A calmer arrival.
A practical family reception.

DESIGN REVIEW · SITE / ENGINEERING HOLD

Recommendation: develop A Calm Contemporary with the shared measured layout. Investigate conditional P1/F1 only after written wall and service approval; A/P0 is the complete enclosed fallback.

Measured operating-state plan

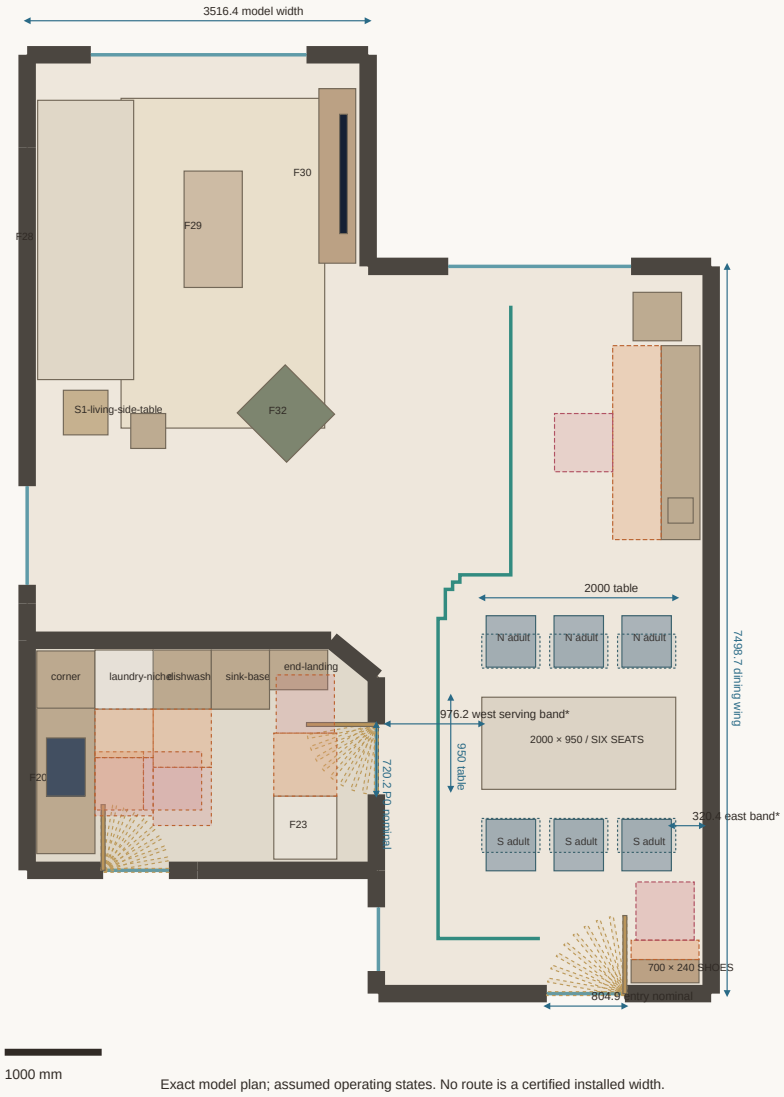
> The entry proposal improves collision results, but its six-pair capacity is unverified. At +450mm chair withdrawal, the shoe user's gap to the nearest chair is only **15mm**: no bypass or physical comfort claim.

Chair / shoes
nearest box gap 915 mm

Chair / shoe user
gap 115 mm

DW + user / south wall
372.3 mm*

West serving band **976.2mm** is the stricter polygon-derived allowance; the partition-axis face calculation is 997.4mm. Preserve the source's 21.2mm discrepancy. East dining band 320.4mm is unsuitable as a through-route. Vector plan: zoom for labels; original SVGs are included.

Read with the +200 and +450 plans. A 700mm circular circulation proxy uses a 75mm grid with 53.0mm radial safety pad. Route endpoints stay inside the entrance/kitchen/terrace. The green line does not certify installed door widths, accessibility or six-adult comfort.

A-P0 · wide-reception
scene-9e86635b · PNG c55cc729a3a6615e
camera f43116963715 · architecture 74234e98afe7

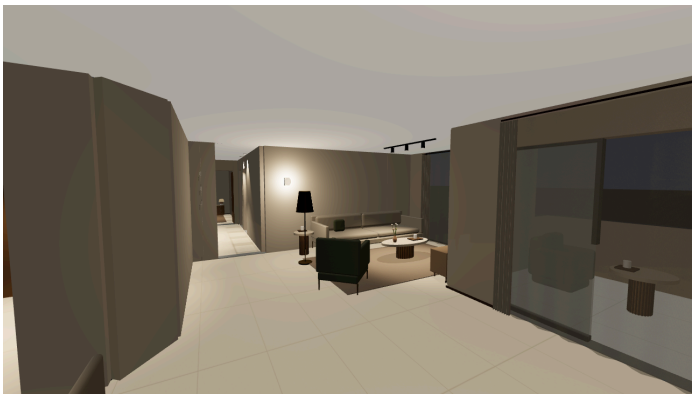
Keep the retained 2880×990 sofa, 2000×950 table and six 510×530 chairs. Sofa–coffee gap stays 520mm. B's pendant underside is 1730mm, 980mm above the table: test heads, serving and glare. No ceiling drop or hidden service void is approved.

The broad dining wall remains intentionally quiet, but could feel plain. Better artwork, real veneer/stone/textile samples and disciplined lighting can supply refinement without adding circulation-blocking objects. Original TV console slats remain visible in both options.

A-P0 · wide-reception-evening
scene-9e86635b · PNG 2b0d070c2325861a
camera c1ccfd49cc30 · architecture 74234e98afe7

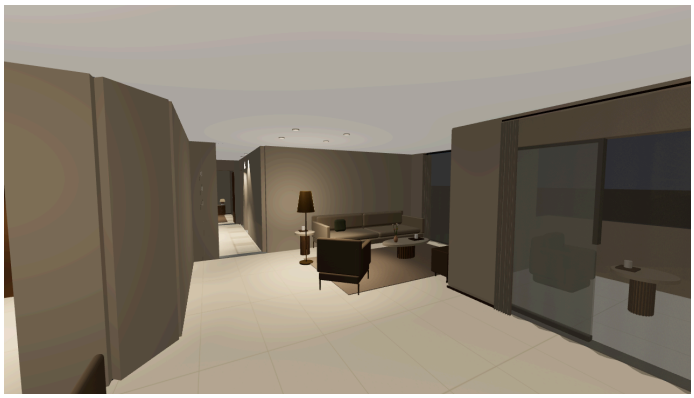
A reads lighter in the evening; B needs a better real reading-light balance. A's bright left-wall lamp patch also needs aiming/dimming. Both show dark terrace glass at night; these are appearance studies, not lux or solar-glare calculations.
